**REGULATION 4 OF THE INFRASTRUCTURE PLANNING (CHANGES TO, AND REVOCATION OF, DEVELOPMENT CONSENT ORDERS) REGULATIONS 2011
APPLICATION TO MAKE A NON-MATERIAL CHANGE TO THE OAKLANDS FARM
SOLAR PARK ORDER 2025 (SI 2025/739) AS CORRECTED BY THE OAKLANDS FARM
SOLAR PARK (CORRECTION) ORDER 2025 (SI 2025/1070)**

EN010122 – Oaklands Farm Solar Project Non-Material Change Application.

Amy Wheelton Independent Seales South Derbyshire District and Linton Division
Derbyshire County Councillor

nsip-documents.planninginspectorate.gov.uk/published-documents/EN010122-000819-EN010122 D7 6.1 ES Chp8 Appx 8.1 Flood Risk Assessment and Outline Drainage Strategy Clean.pdf

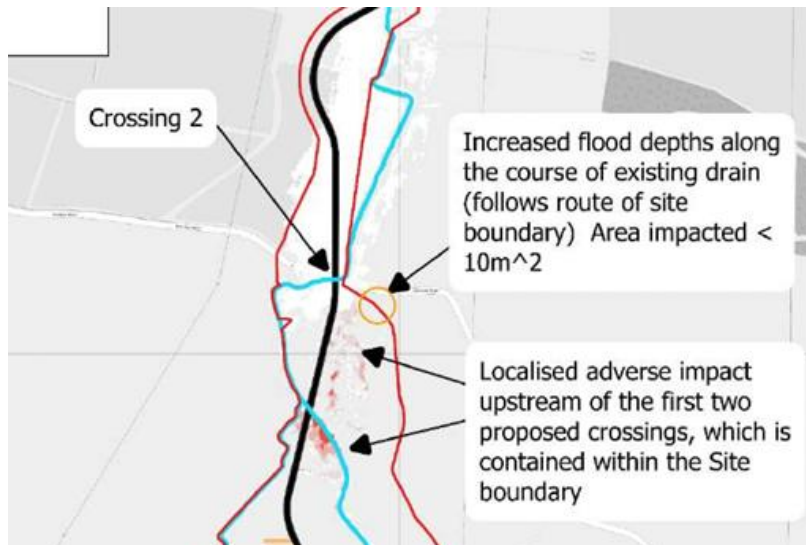
Please note for all these conditions it does not fulfil the requirements of the Development Consent Order (DCO) in that the submitted details do not “include the plans and strategies referred to in the flood risk assessment” as required by Requirement 17 part 2 of the DCO as they are not in accordance with the flood risk assessment which shows clearly land near Rosliston road may flood by up to 20cm. Please refer to FRA document dated Dec 2024.
